Access Compliance Report

Public Rights-of-Way

Intersection ID: 49929	Main Street: ASHBOURNE_HALL_RD	Cross Street: CHAMBERLIN_RD	Location: SE
ADA ID: 91D2EE9A5065	Ramp Type: Perp	Initial Pass/Fail: Pass	Overall Compliance: No
Severity Score: 5			
Codes/Mitigation Info/Possible Solution		Field Measurements/Component Compliance

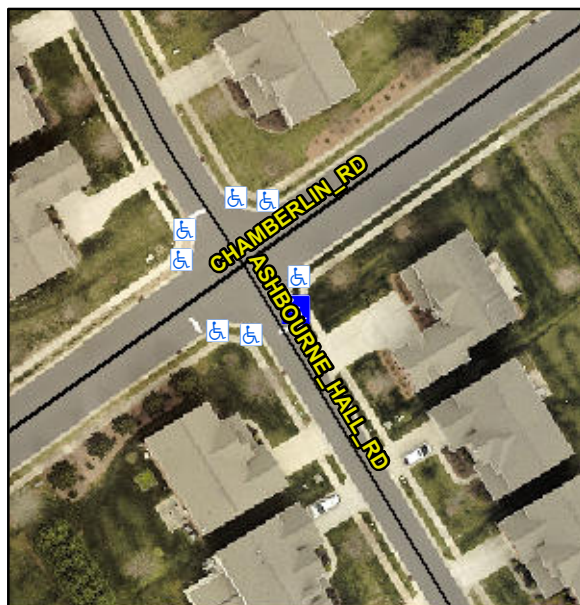
**Not Found, R304.2.1, R304.5.3,
R305.2, R304.5.4**

Compliance	Description	Data	Compliance	Description	Data
N/A	Ramp Length (in)	47.0	Yes	Ramp Slope (%)	7.9
Yes	Ramp Width (in)	48.0	Yes	Ramp XSlope (%)	1.0
N/A	Flare Type LT	Sloped	N/A	Flare Type RT	N/A
N/A	Flare Slope LT (%)	8.4	Yes	Flare Slope RT (%)	7.9
N/A	Flare Traversable LT?	Yes	N/A	Flare Traversable RT?	Yes
No	Landing Length (in)	47.0	Yes	DWS Provided?	Yes
Yes	Landing Width (in)	48.0	Yes	DWS Contrast?	Yes
Yes	Landing Slope (%)	1.6	Yes	DWS Length (in)	24.5
No	Landing X Slope (%)	2.1	Yes	DWS Full Width?	Yes
N/A	Landing Curb? (Y/N)	No	No	DWS Offset (in)	6.0
N/A	Shared Landing?	No			
Yes	Gutter Ponding?	No	No	Gutter Slope (%)	5.8
Yes	Gutter Lip Ht (in)	0.0	Yes	Gutter X Slope (%)	1.7
N/A	Painted X Walk1?	No	N/A	Painted X Walk2?	N/A
	X Walk 1 Direction	To SW		X Walk 2 Direction	N/A
N/A	X Walk 1 Width (in)	N/A	N/A	X Walk 2 Width (in)	N/A
	X Walk 1 Slope (%)	3.8		X Walk 2 Slope (%)	N/A
	X Walk 1 X Slope (%)	2.8		X Walk 2 X Slope (%)	N/A

N/A	Ramp inside XWalk1?	N/A	N/A	Ramp inside XWalk2?	N/A
	Road Slope (%)	N/A	N/A	Clear Space?	Yes
	Road X Slope (%)	N/A	N/A	Clear Space to XWalk (in)	N/A
Yes	Any Obstructions?	No	Yes	Storm Grate/Utility Hazard?	No
	Obstruction Type			Storm Grate/Utility Type	
		N/A			N/A
			Yes	Surface Condition? (G/P)	Good

**Remove & Replace Entire Ramp.
Remove & Replace Gutter.**
